Access Compliance Report

Public Rights-of-Way

Intersection ID: 14726	Main Street: REMOUNT_RD	Cross Street: S_TRYON_ST	Location: E
ADA ID: 05C4CE0DA54A	Ramp Type: Perp	Initial Pass/Fail: Fail	Overall Compliance: No
			Severity Score: 13.75

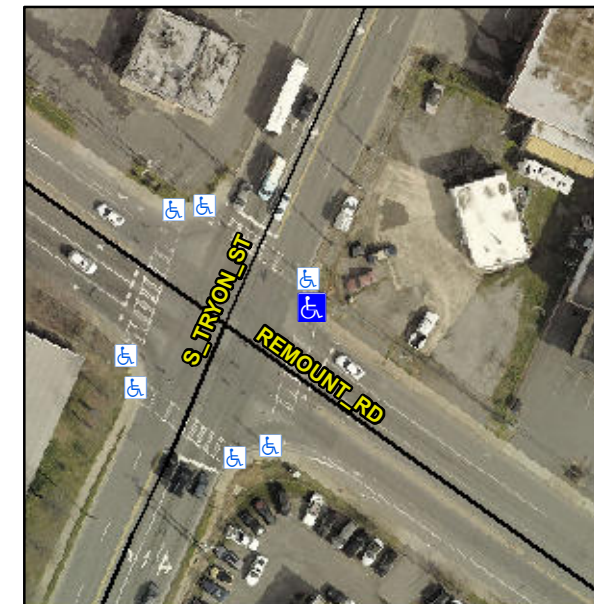
Not Found, R304.2.2, R304.5.3

Compliance	Description	Data	Compliance	Description	Data
N/A	Ramp Length (in)	59.0	No	Ramp Slope (%)	8.9
Yes	Ramp Width (in)	54.0	No	Ramp XSlope (%)	2.3
N/A	Flare Type LT	N/A	N/A	Flare Type RT	N/A
N/A	Flare Slope LT (%)	N/A	N/A	Flare Slope RT (%)	N/A
N/A	Flare Traversable LT?	N/A	N/A	Flare Traversable RT?	N/A
N/A	Landing Length (in)	N/A	N/A	DWS Provided?	N/A
N/A	Landing Width (in)	N/A	N/A	DWS Contrast?	N/A
N/A	Landing Slope (%)	N/A	N/A	DWS Length (in)	N/A
N/A	Landing X Slope (%)	N/A	N/A	DWS Full Width?	N/A
N/A	Landing Curb? (Y/N)	N/A	N/A	DWS Offset (in)	N/A
N/A	Shared Landing?	N/A			
N/A	Gutter Ponding?	N/A	N/A	Gutter Slope (%)	N/A
N/A	Gutter Lip Ht (in)	N/A	N/A	Gutter X Slope (%)	N/A
N/A	Painted X Walk1?	Yes	N/A	Painted X Walk2?	N/A
	X Walk 1 Direction	To SW		X Walk 2 Direction	N/A
N/A	X Walk 1 Width (in)	108.0	N/A	X Walk 2 Width (in)	N/A
	X Walk 1 Slope (%)	1.5		X Walk 2 Slope (%)	N/A
	X Walk 1 X Slope (%)	0.8		X Walk 2 X Slope (%)	N/A

Remove & Replace Entire Ramp.
